101 SALMON STREET, PORT MELBOURNE

LOCATION/ADDRESS: 101 SALMON STREET, PORT MELBOURNE
EXECUTIVE MEMBER: LILI ROSIC, GENERAL MANAGER, CITY STRATEGY AND SUSTAINABLE DEVELOPMENT
PREPARED BY: SIMON GUTTERIDGE, PLANNING TEAM LEADER FISHERMANS BEND

1.1 To provide a Council position on Ministerial Application 2014/002000-1 at 101 Salmon Street, Port Melbourne, to amend the existing permit under Section 72 of the Planning and Environment Act 1987 including the alteration of plans, permit conditions and permit preamble.

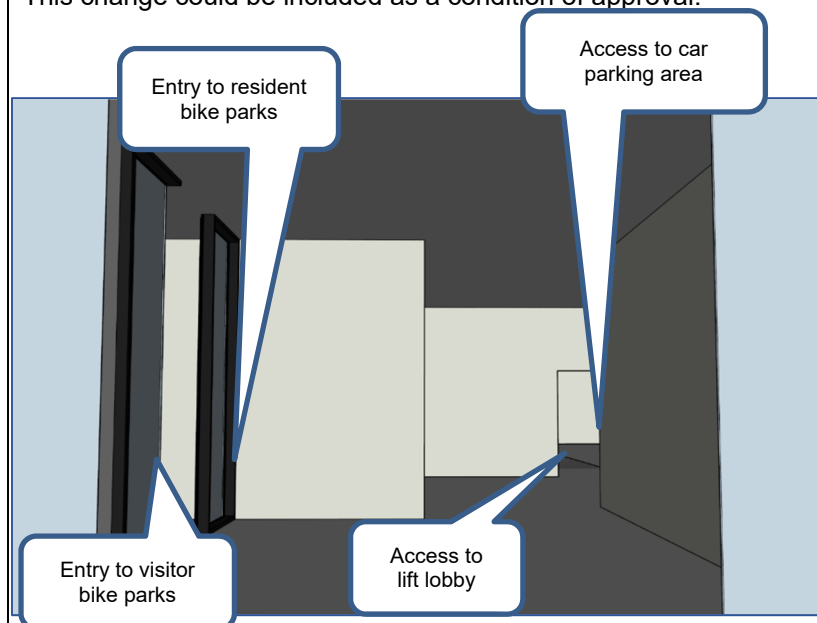
The residential entry area does not comply with planning policy (particularly Clause 58.05-2), particularly:

- It does not have an easily identifiable entry from Salmon Street that is clearly distinguishable from the commercial entry;
- It has limited visual connection with the street as the services (booster and meters) extend across 50% of the entry frontage;
- It has a lengthy and circuitous route to the lift lobby with no direct line of sight and several areas / corners of potential concealment (refer to snapshot from proponent’s 3D model on next page);
- The innermost area (including lift lobby) will have limited access to natural light and ventilation; and
- It includes access for resident and visitor bicycle parking areas, which could result in user conflicts.

Some of these issues could potentially be readily addressed, through relocation of the building services to the laneway and minor layout changes. The residential entry could be improved with a variation in the façade and canopy design. More significant changes, however, will likely be required to ensure the safe, functional and efficient movement of residents between the street and lift lobby.

These changes could potentially be included as a condition of approval for a revised residential entry design to be provided on amended plans. Detailed design of the street entry could be approved at a later stage.

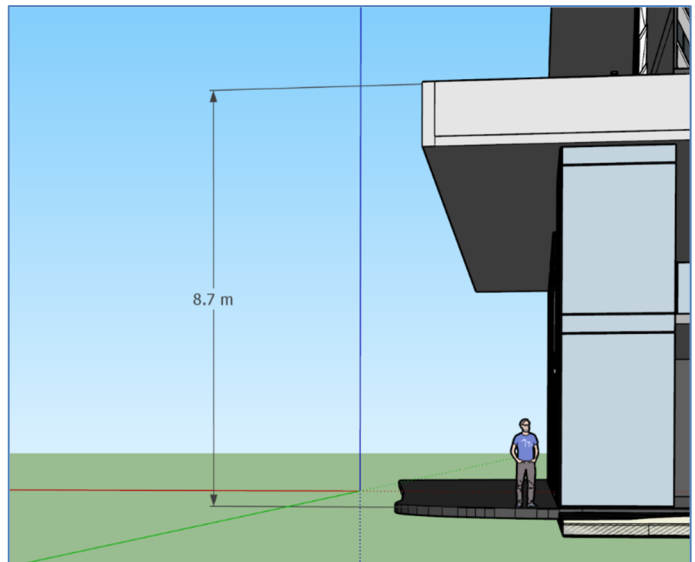
<p>Environmentally Sustainable Design</p>	<p>The following changes to plans are recommended</p> <ul style="list-style-type: none"> - Roof plan should include notation for 100kWp solar PV system and solar pre-heat for domestic hot water system (as committed to in SMP). - Eight electric vehicle parking bays to be nominated on floor plans (as committed to in SMP). - Ground floor plan end of trip area to include notation for showers, which are currently shown as cubicles. - The bike parking looks tight the configuration should be represented at a larger scale than the floor plans (such as the BADS assessment provided for apartment floor plans) should be provided at 1:50. - There is also no condition on the current permit relating to landscaping. Suggest that a detailed landscaping plan be required by condition containing a notation about the irrigation system specified in the SMP. - Provision of a landscape plan should also be required to demonstrate commitment to 2.5% of site containing native planting, as per commitment in the Ecology section of the SMP. - Floor plan to nominate connection point to precinct-wide third pipe system, as committed to in SMP and consistent with condition 12 of the existing permit. - There are inconsistencies between SMP details of rainwater harvesting and details shown on plans. SMP refers to a 95kL tank, whereas the ground floor plan shows a tank of 60m³. Also the roof catchment area in m² above level 11 is noted differently

<p>on the plans and in the SMP. These need to be consistent to demonstrate that stormwater quality objectives can be met.</p> <ul style="list-style-type: none"> - No tank for fire system test water shown on plans. - More detail required for each of the innovation credits claimed. - The project must meet the general Green Star credit requirements in this area before they can claim the innovation credit. - Nominate location of 6 electric bicycle parking spaces and charging infrastructure on floor plans. - Indoor plants commitment in SMP relates to primary and secondary spaces.
--	--
